The Committee of 100

September 16, 2026

RE: Section 106 Consultation, Triumphal Arch – Assessment of Effects and Failure to Consider
Alternative Locations: Comments of the Committee of 100 on the Federal City

Source: 1924 Bridge Commission Report, p. 52, columns indicated with red arrows.

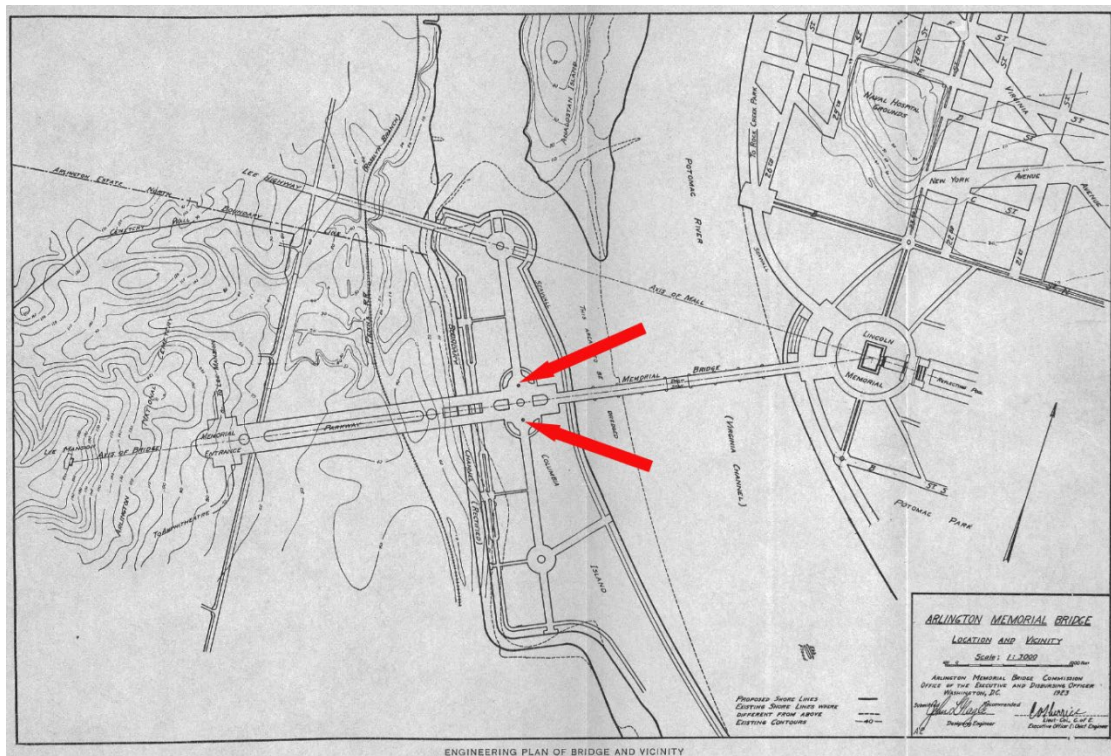
Scaled drawings accompanying the text (in plates in the 1924 report) place the two columns at approximately 300 feet apart, with diameters of less than 15 feet above the column base:

The distance between the columns, and their slender design, were intentional: The specific language of the 1924 Commission report makes clear that the additional architectural elements contemplated for the center of Columbia Island, i.e. the two columns, were to be (1) “supplemental” to the Lincoln Memorial, and (2) “not interfering” with the view of the Lincoln Memorial from Lee Mansion, at the heart of Arlington Memorial Cemetery. Two narrow columns 300 feet apart would have met these key 1924 design criteria; a massive triumphal arch would not.

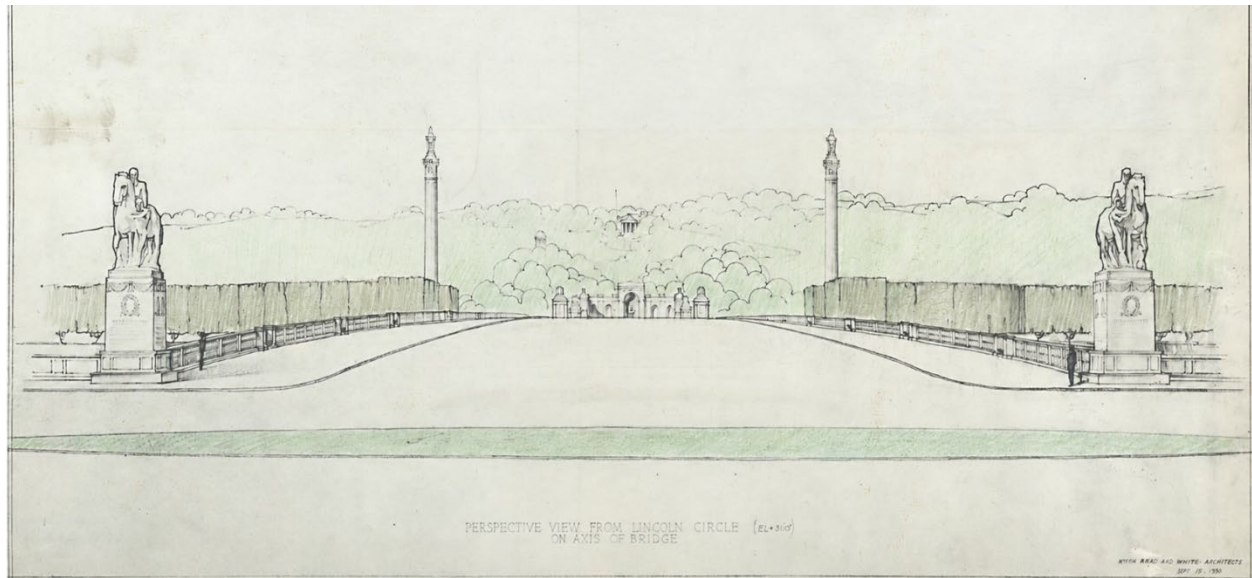
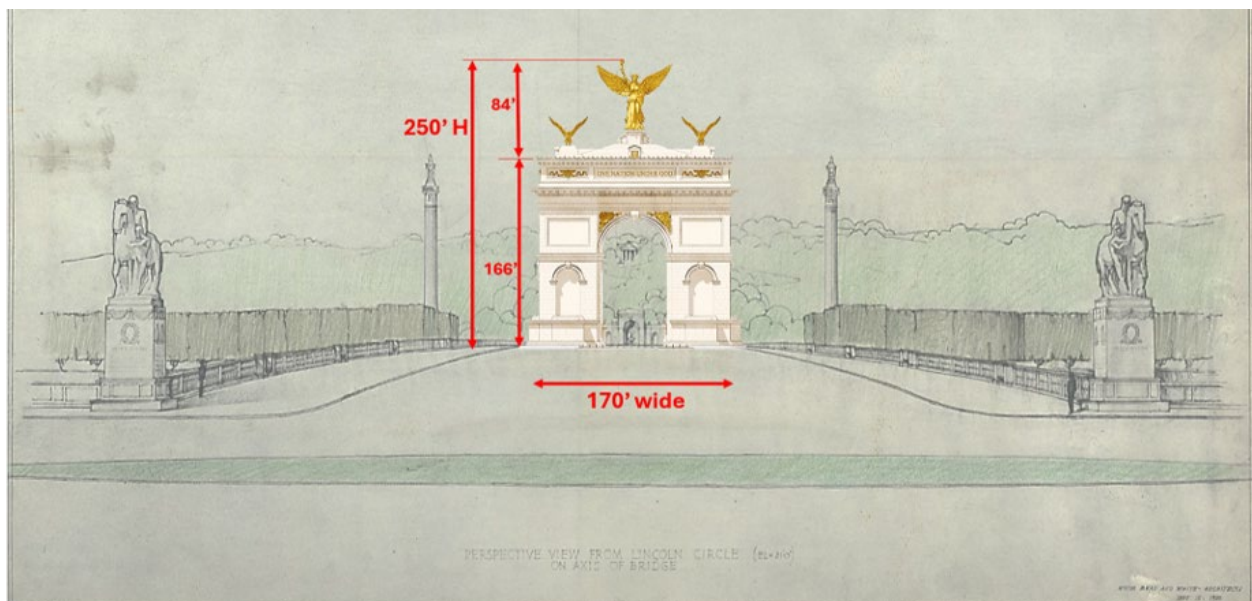
A nearly contemporaneous rendering of a view across the proposed Memorial Bridge showing the two columns, by McKim, Mead and White, shows how open the viewshed would remain towards Arlington Memorial Cemetery.

The same view with the proposed Triumphal Arch superimposed makes clear that the proposal not only would not “complete” the 1924 design, but it is also plainly incompatible with it:

It is impossible to reconcile these illustrations with the NPS’s determination that a massive triumphal arch—more than twice the height of the Lincoln Memorial and significantly blocking views between that memorial and the Arlington Memorial Cemetery—would somehow “complete a

historically contemplated commemorative feature at Memorial Circle.” In terms of size, scale, massing, and design, the proposed arch is not in any way comparable to the unbuilt columns contemplated in the 1924 design proposal; moreover, it would blatantly violate the two 1924 design criteria fundamental to the intended design of that unbuilt commemorative feature.¹
